LED SUBSTITUTE PROPOSAL

INTRODUCTION:

NEW SOCKET FOR PY21W/LED COMPATIBLE WITH PY21W.

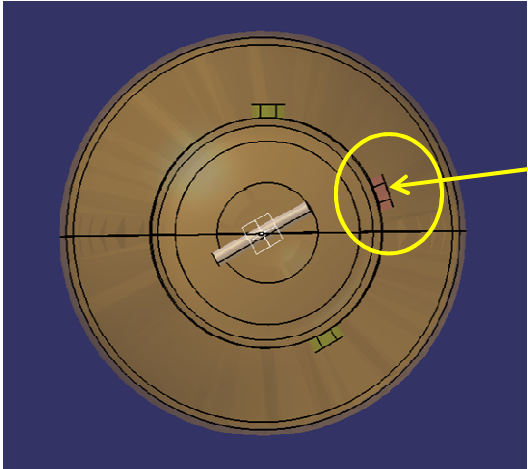
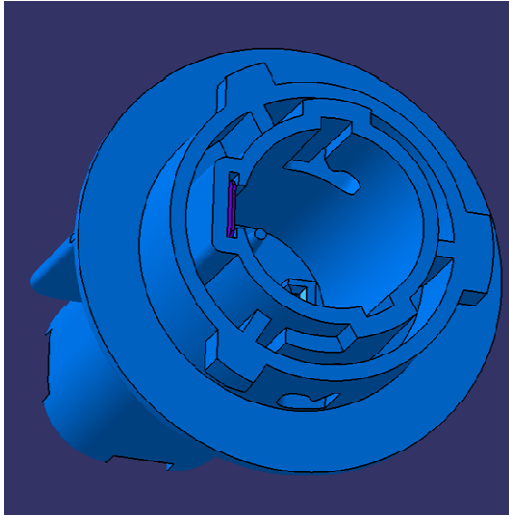
A different cap for LED substitutes compatible with filament light sources can solve this issue.

Existing PY21W Bulb holder

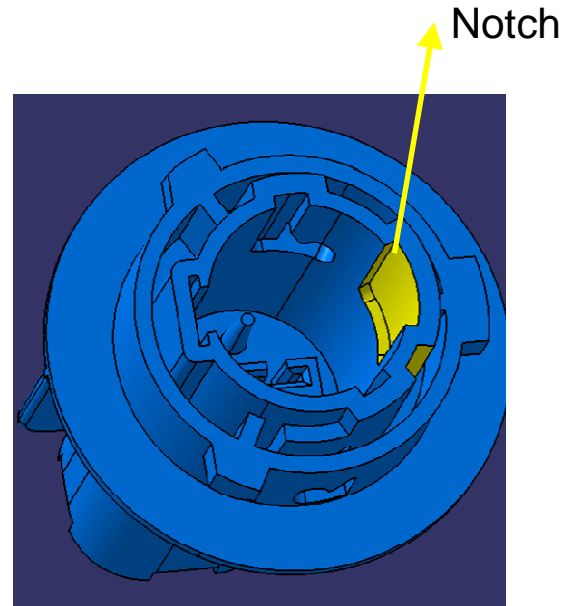
MOUNTING OF PY21W/LED IN THE BULB HOLDER. SOLUTION COMPATIBLE WITH THE REGULATION REQUIREMENT.

LED substitutes socket

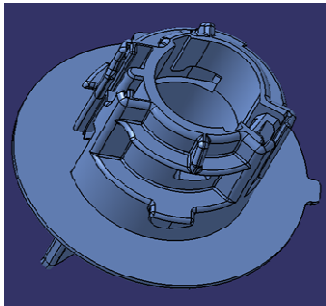
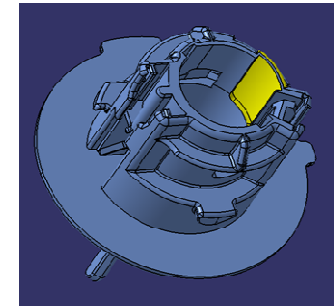
This keying makes impossible to put LED substitute in existing bulb holder by mistake..

LED substitutes socket

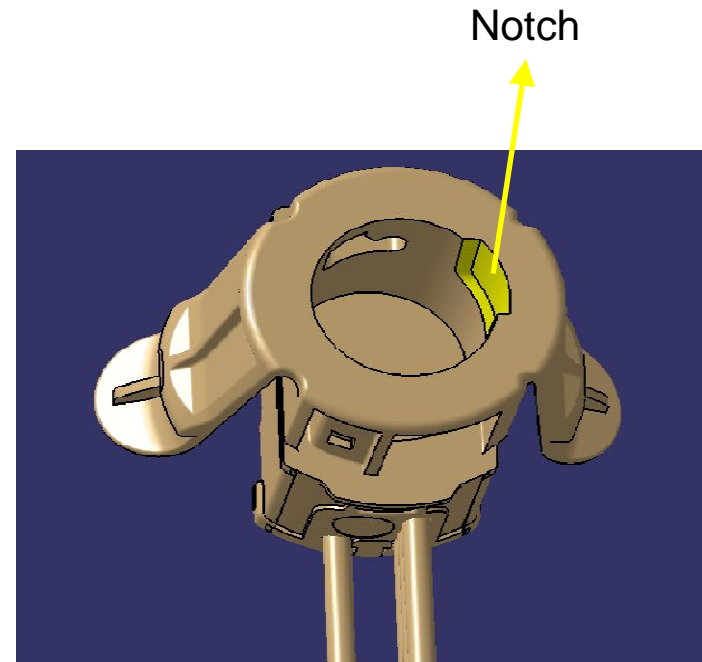
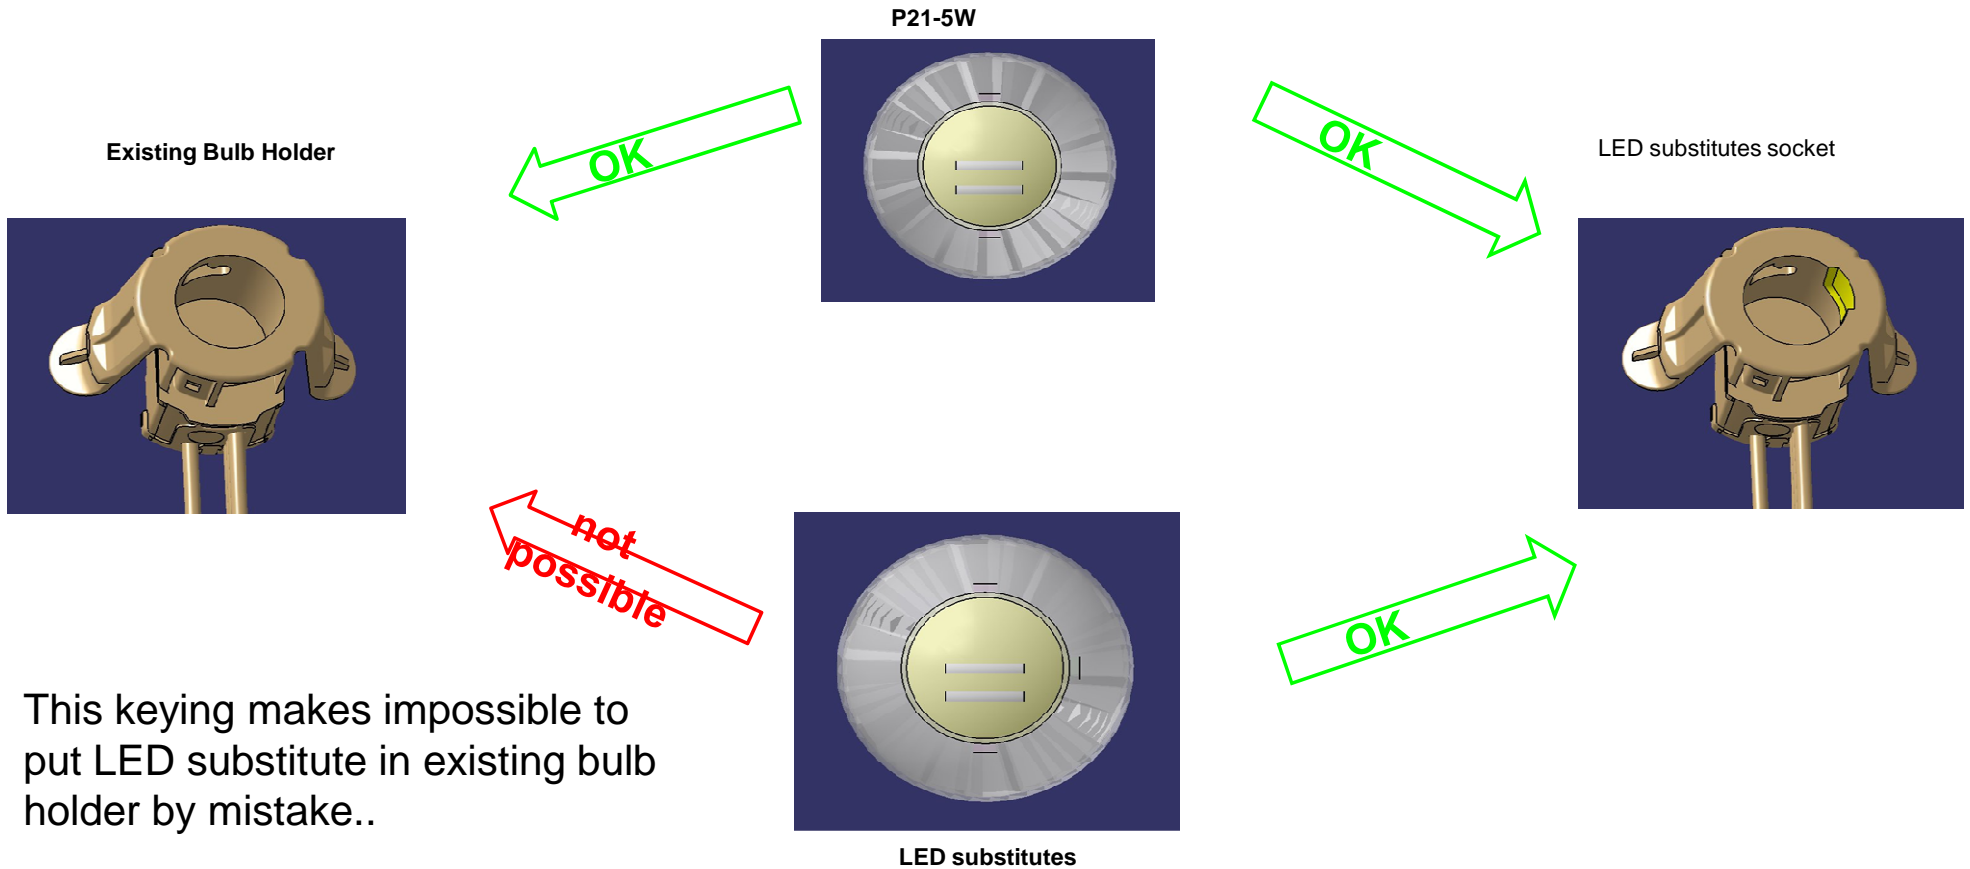
MOUNTING OF P21/5W/LED IN THE BULB HOLDER. SOLUTION COMPATIBLE WITH THE REGULATION REQUIREMENT.

Extract from TFSR-01-09e page 10

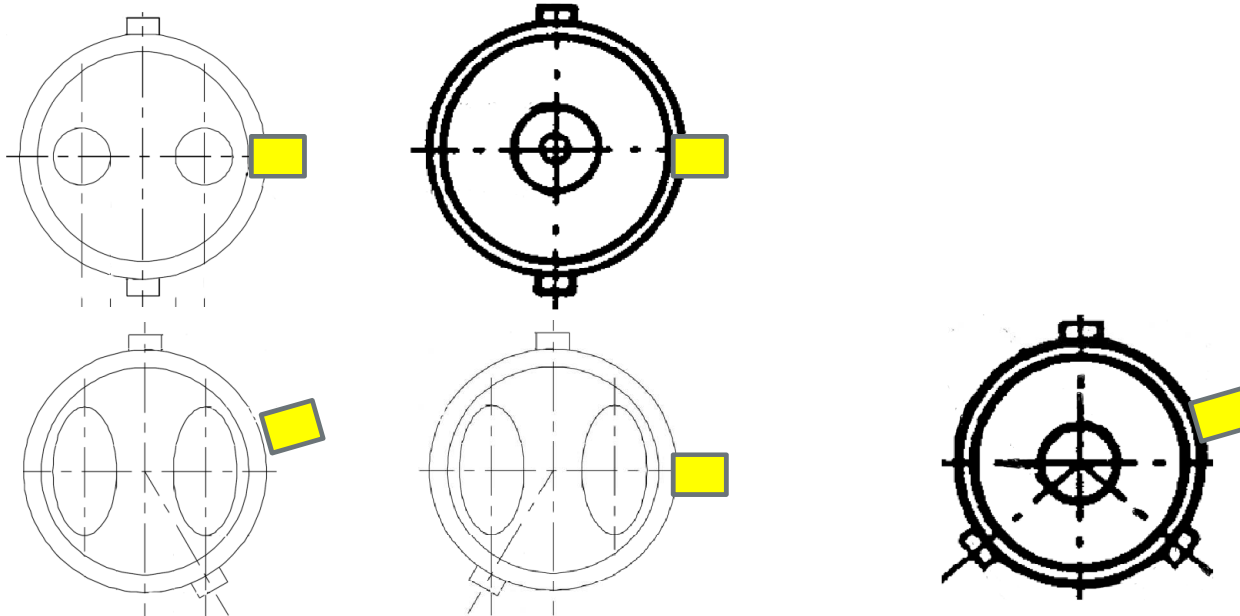
The possibility to put the addition pin () in another plan than the one where the existing pins are located should be investigated (see page 17).

Extract from TFSR-01-09e page 10

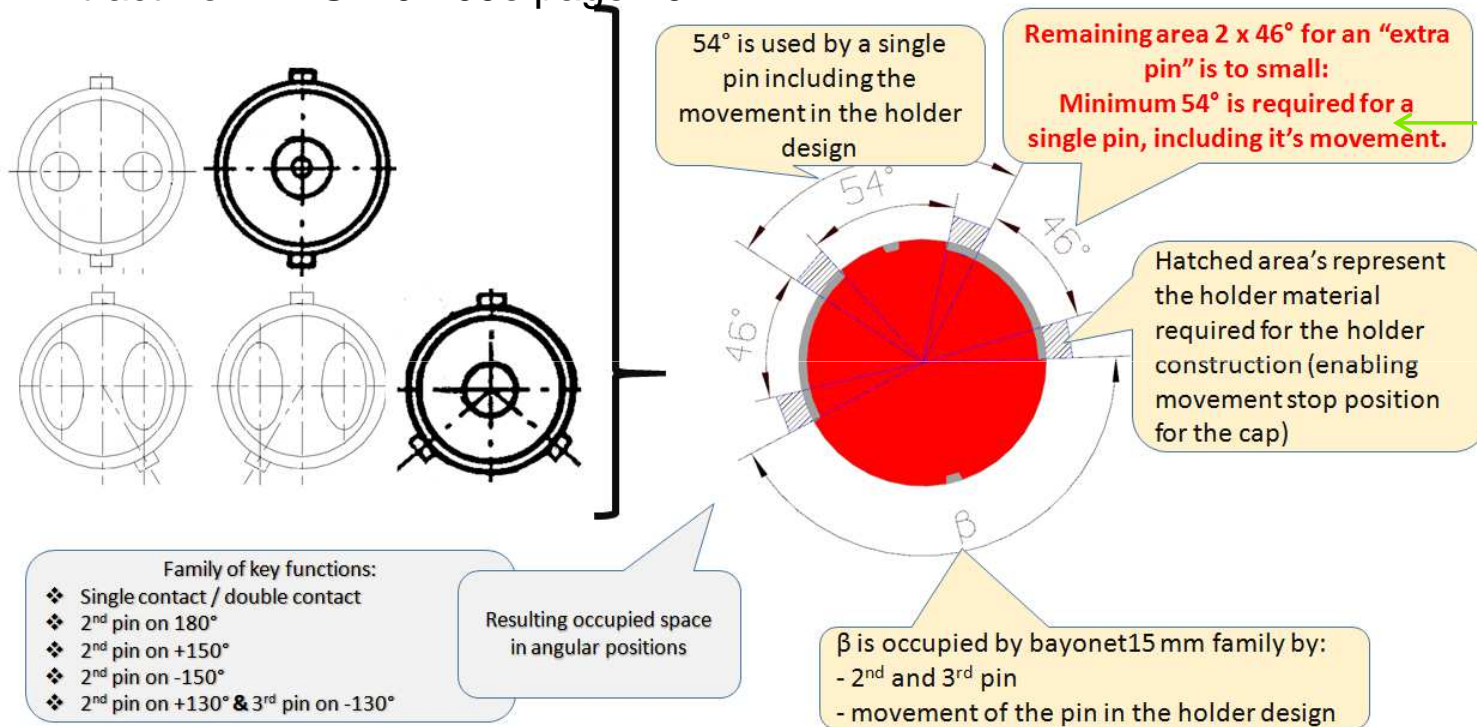
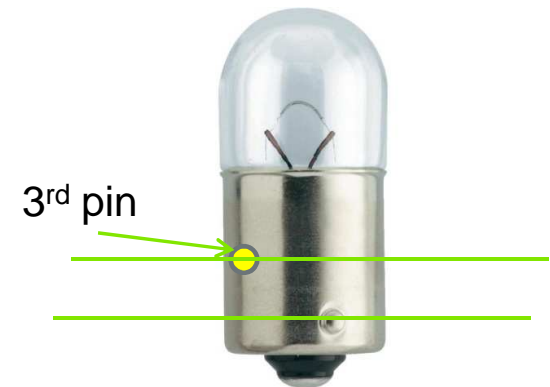
For which reason the 3rd pin for preventing incorrect assembly light source/ lamp must be only in these angular sectors?

If any problem remains, the additional pin can be in another plan that the initial ones.
